From: Leidy, Robert
Sent: Tuesday, July 22, 2014 11:12 AM
To: Lomeli, Ben
Cc: Jeffrey Simms; Simms, Karen M
Subject: RE: SWCA Revised FEIS modeling approach

Attached please find a PDF of a 2005 groundwater study quantifying pumpage in the Sonoita area.

REVIEW OF USFS MODEL AND AN ALTERNATIVE APPROACH TO INFORM THE EFFECTS OF GROUNDWATER DRAWDOWN ON CIENEGA CREEK

Prepared for: Coronado National Forest
Prepared by: Rosemont Copper Company
Date: June 6, 2014

Figure 3. Probability plots with 95% confidence limits for normal and lognormal distributions.

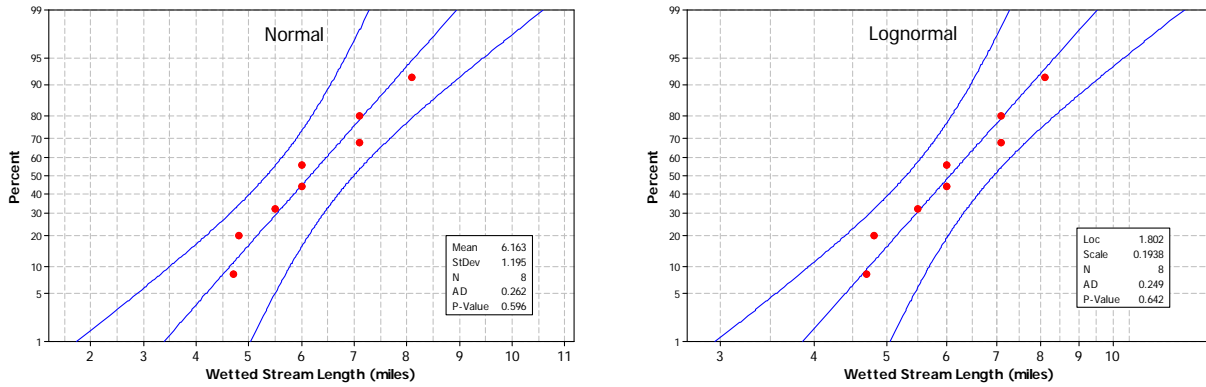
Based on the Anderson-Darling test, the normal and lognormal distributions provide the best fit to the wetted stream length data; all other distributions tested produced a worse fit to the observed data. **Figure 3** shows probability plots for the normal and lognormal distributions.

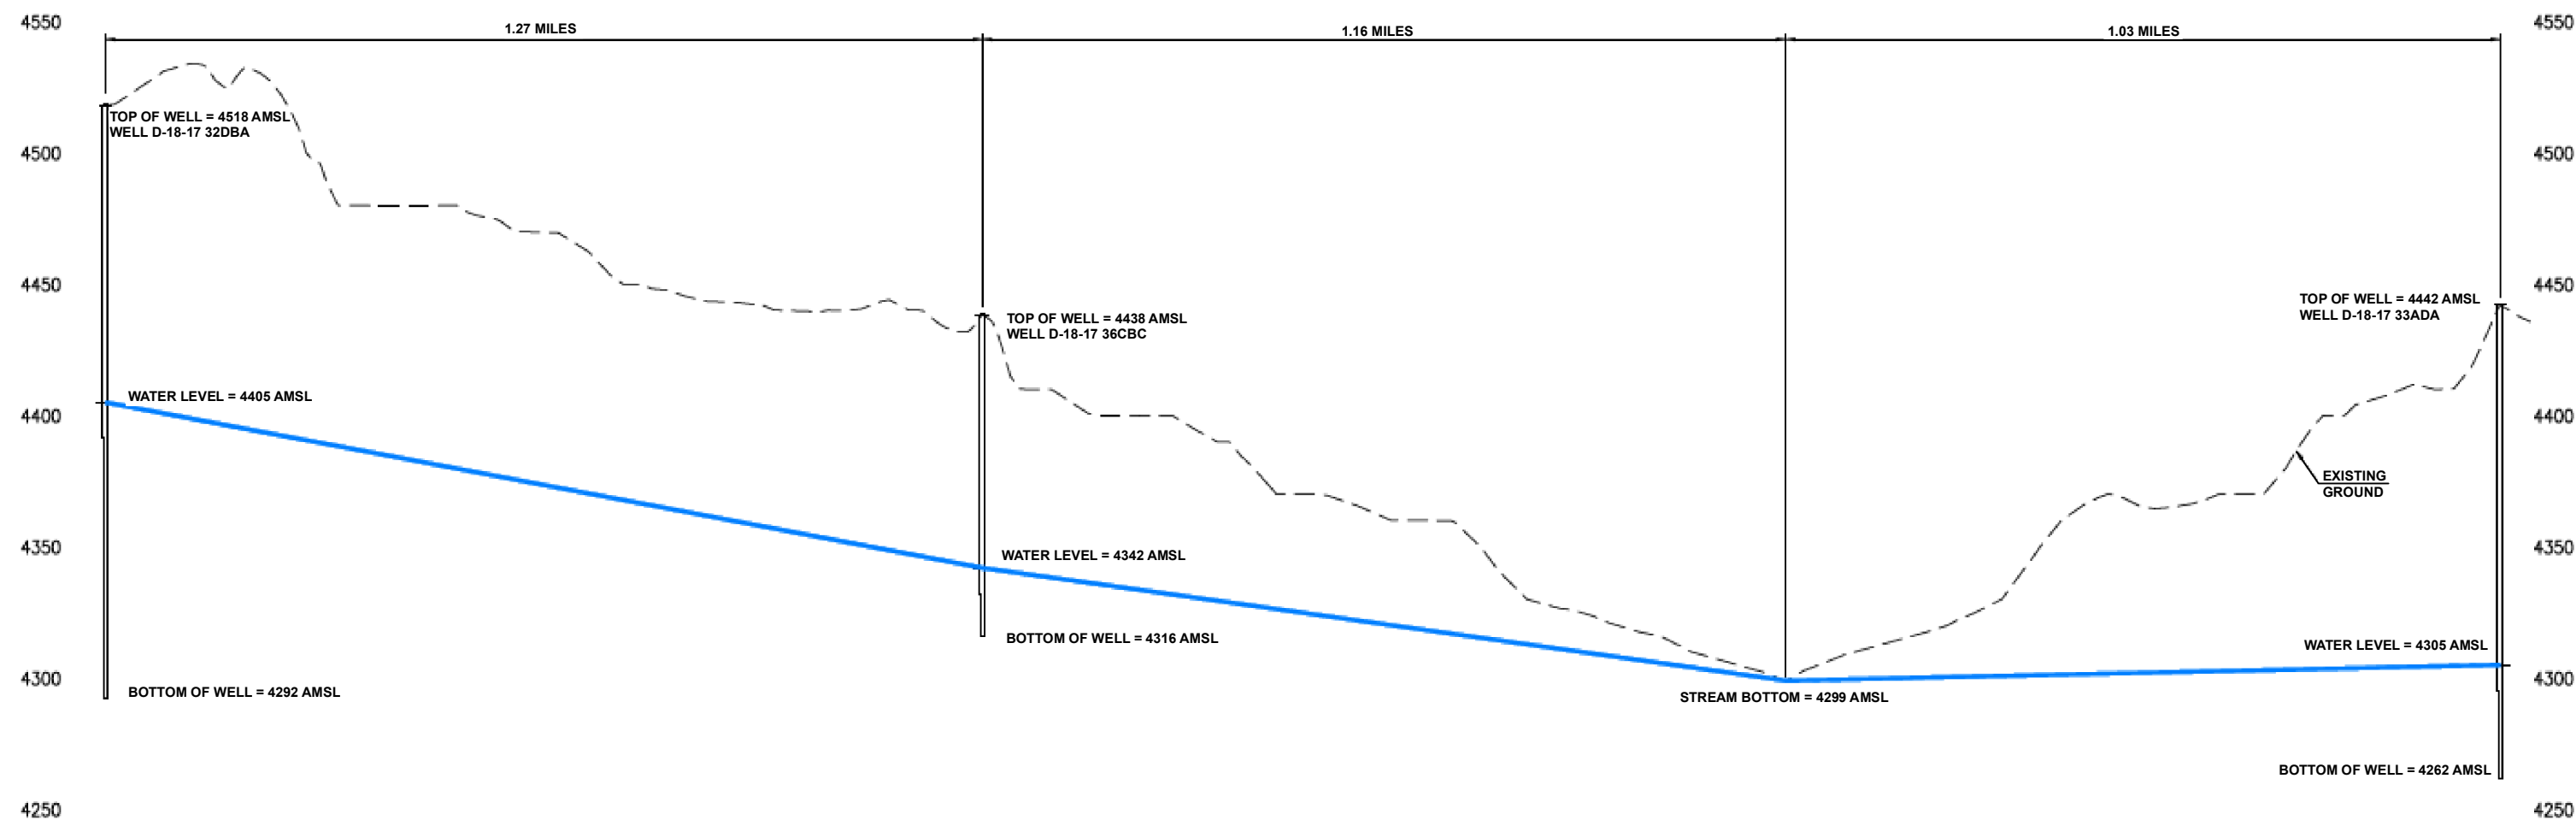
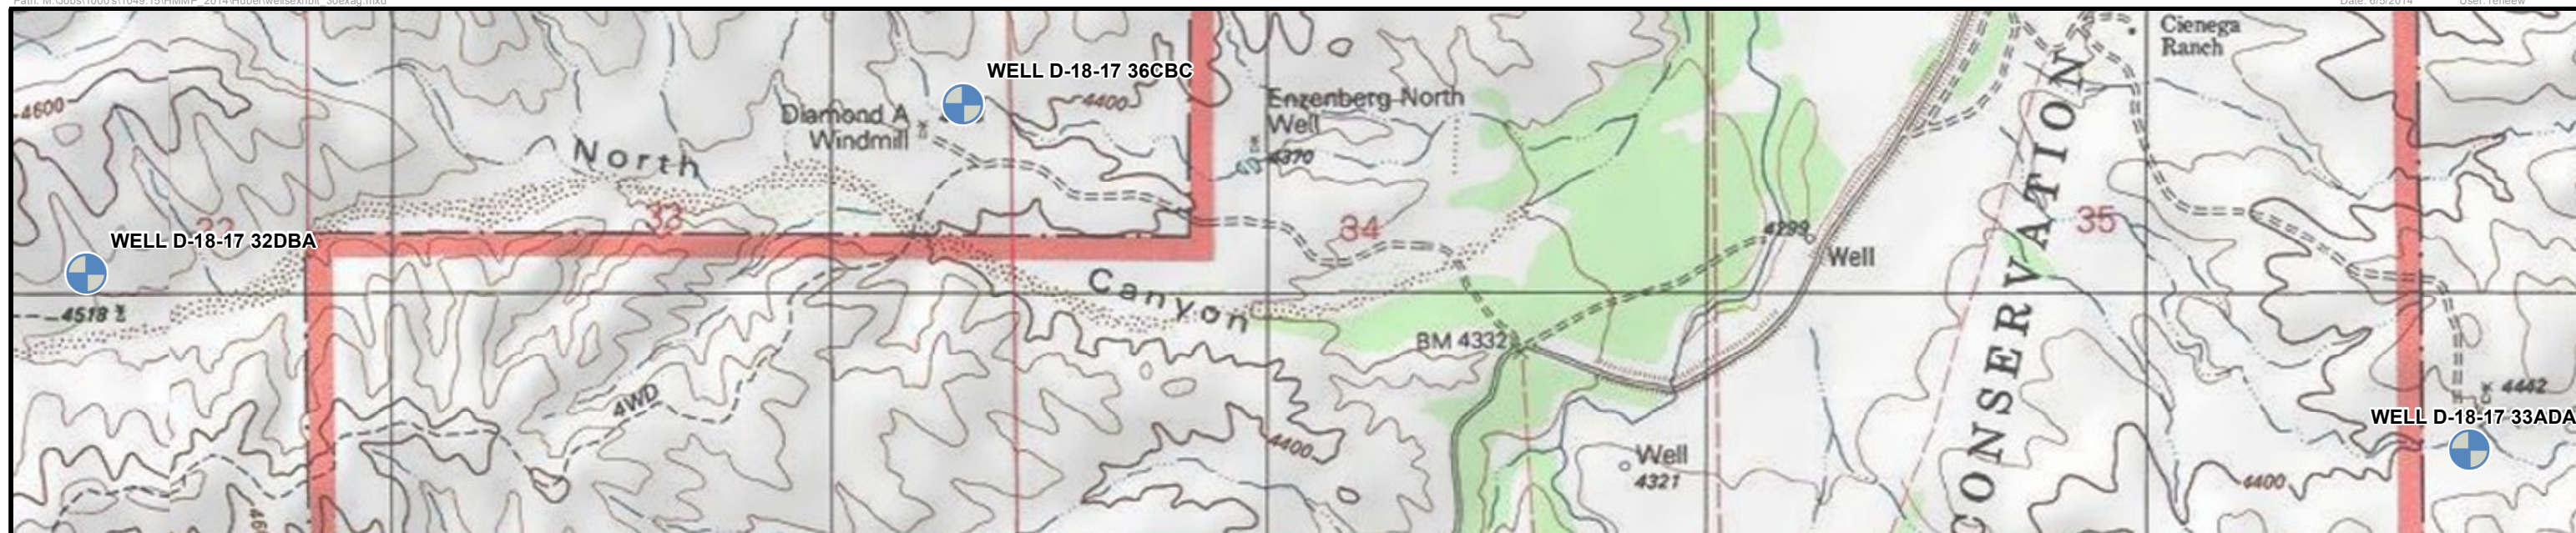
The cross-section shown on Figure 1 illustrates that groundwater flow in the Upper Cienega Creek valley flows from the mountain fronts toward the creek (valley axis) then flows northward, generally parallel to surface flow. Water level elevations in the three wells define the hydraulic gradient across the stream valley. (The hydraulic gradient between any two points is the slope of the hydraulic head between those points.)

The hydraulic gradient as shown on Figure 1 was obtained by calculating the difference in head between each of the wells and the stream channel. The difference in head between wells (D-18-17) 32DBA and (D-18-17) 33ADA is 63 feet (4405 – 4342). Since the distance between the wells is 6,213 feet, the hydraulic gradient between these two wells is therefore $63/6213 = 0.010$ (1%).

The assumption used in creating the cross-section shown on Figure 1 is that base flow in Cienega Creek is hydraulically connected to the regional groundwater flow system and that all three wells are completed in the same unconfined, homogeneous regional groundwater flow system. This assumption was used in the Montgomery & Associates (2010) and Tetra Tech (2010) groundwater models, and was also used in the SWCA analysis to develop the 1:1 relationship.

If, under worst-case scenario groundwater drawdown from the Project decreased groundwater levels in the two wells located on the west side of Cienega Creek, the hydraulic gradient between the wells and the creek would also decrease. Using the 0.1% slope (from the east side of the creek) as the worst-case scenario, a decrease in gradient to 0.1% on the west side reveals that wells 32DBA and 33ADA could experience a water level decrease of up to 93 feet and 36 feet, respectively, and still contribute stream flow to Cienega Creek.
